**BUILDING 500
FOR
HOLY ANGELS HOTEL**
3500 ST. CLAUDE AVE, NEW ORLEANS, LA 70117

BUILDING 500
SK21
Sheet No.

Per the HDLC ARC at its Tuesday, August 16, 2022 meeting - "An additional horizontal panel at the right side of the screen should be added."

1 EQUIPMENT YARD SIDE ELEVATION (FACING BUILDING 500)
SK21 1/4" = 1'-0"

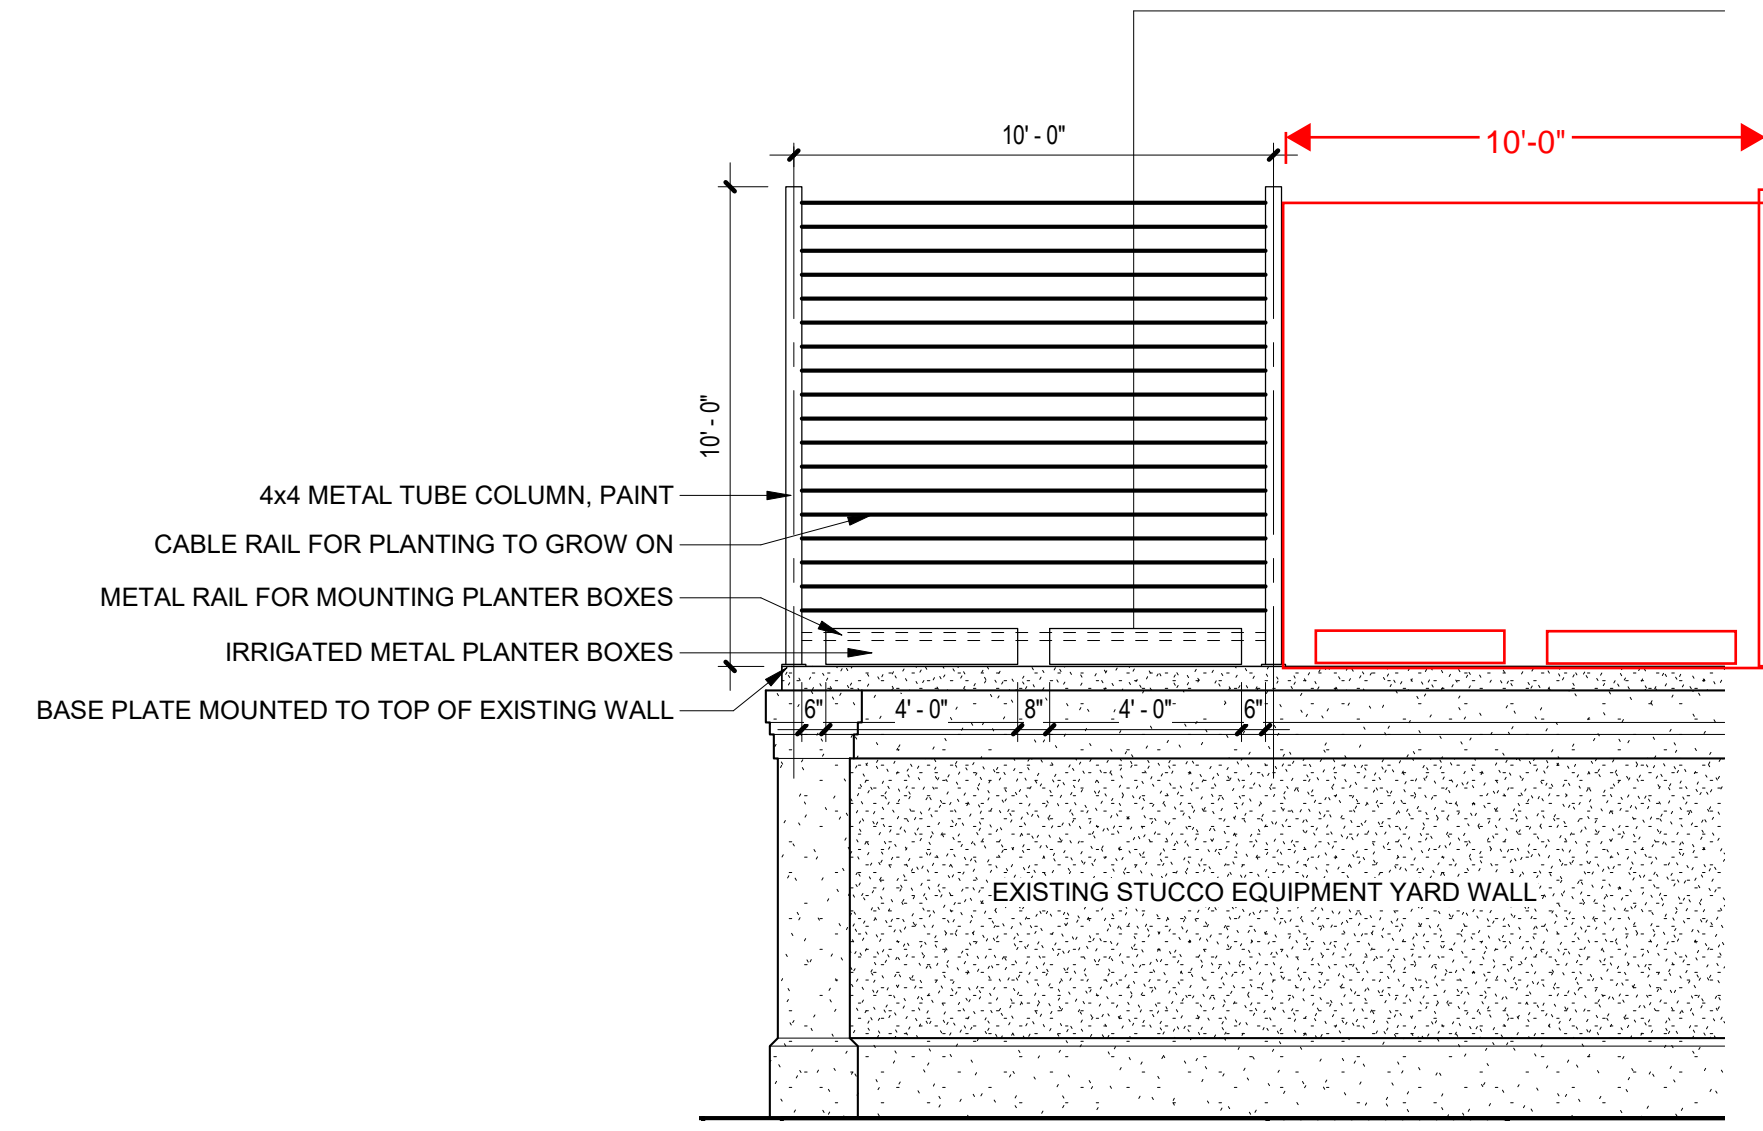
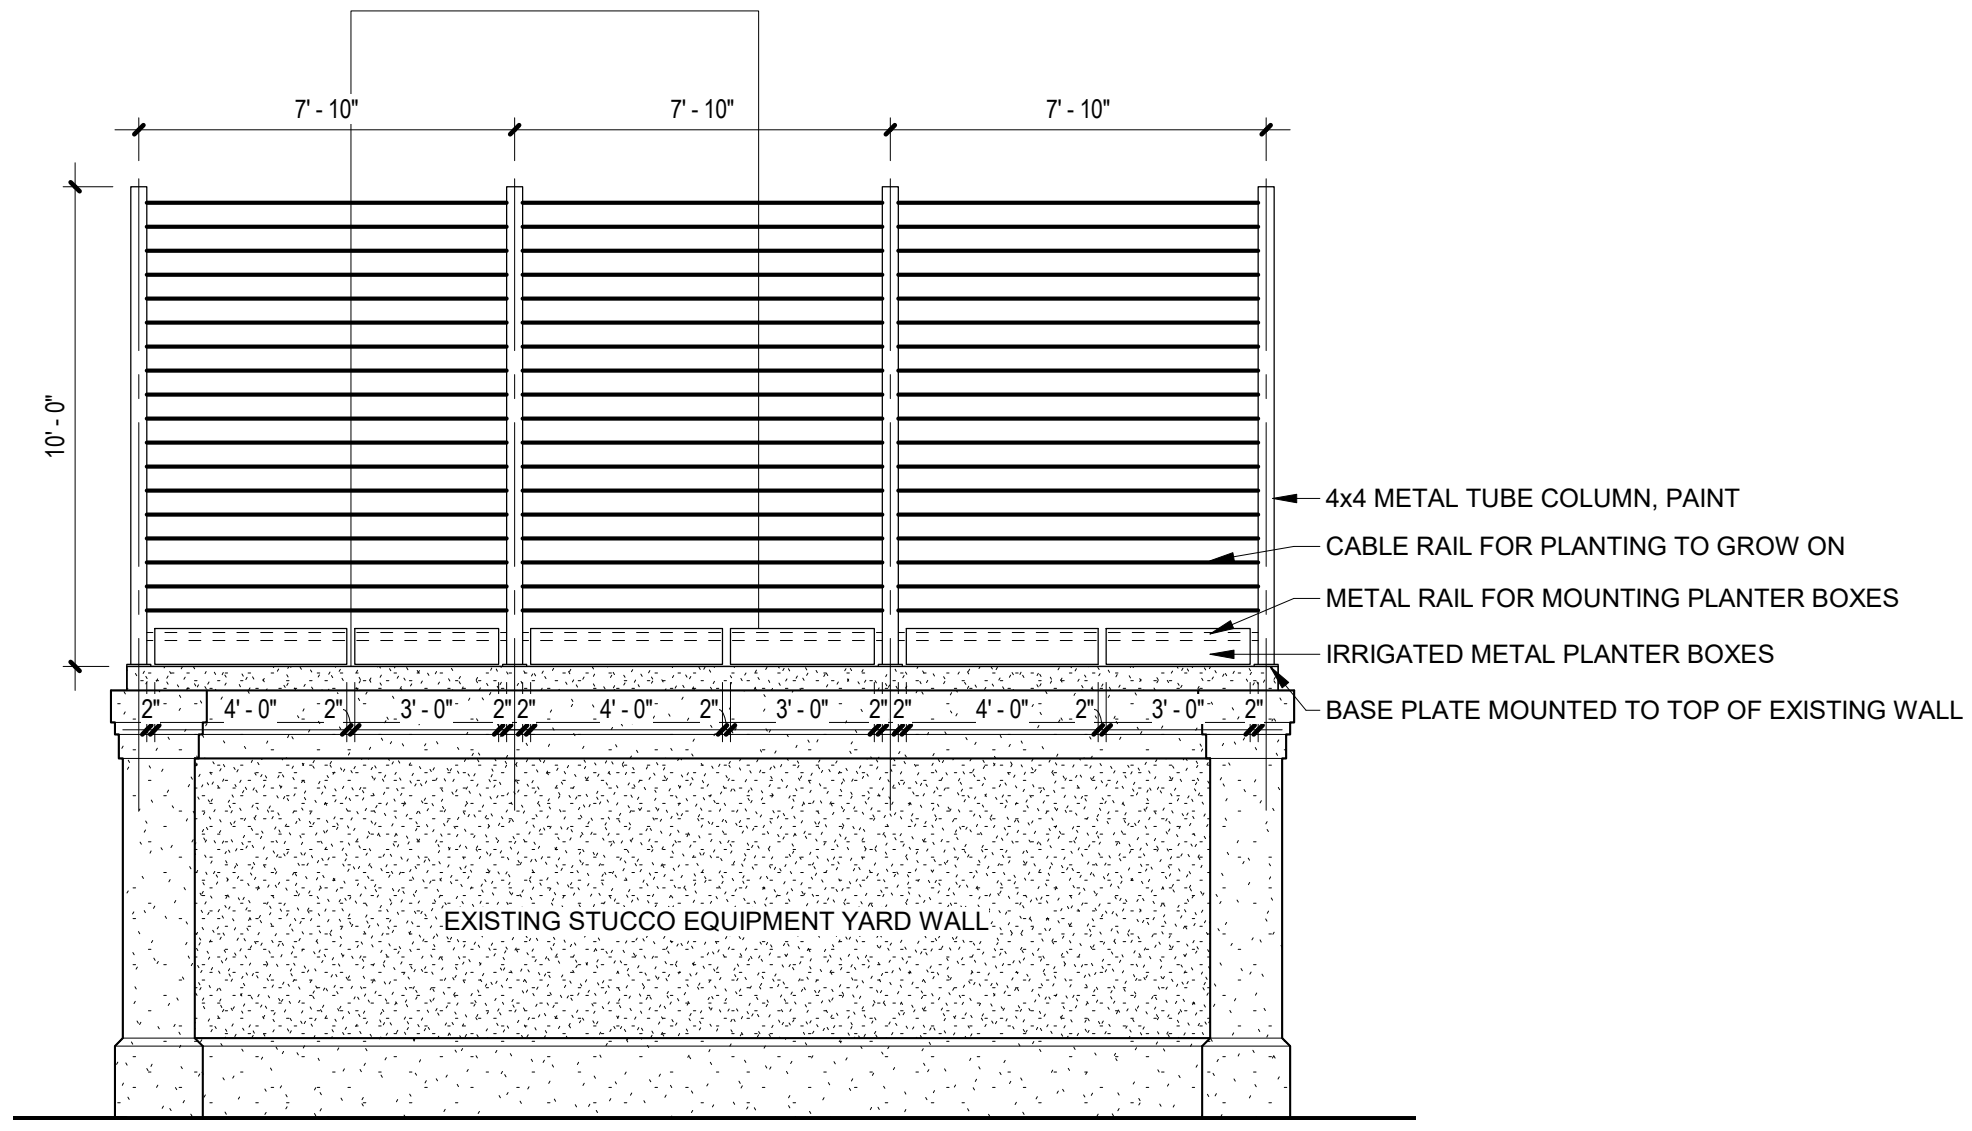
Add horizontal panel at right side at the 10'0" measurement to match left side panels. Include the same irrigated metal planter boxes and cable rails.
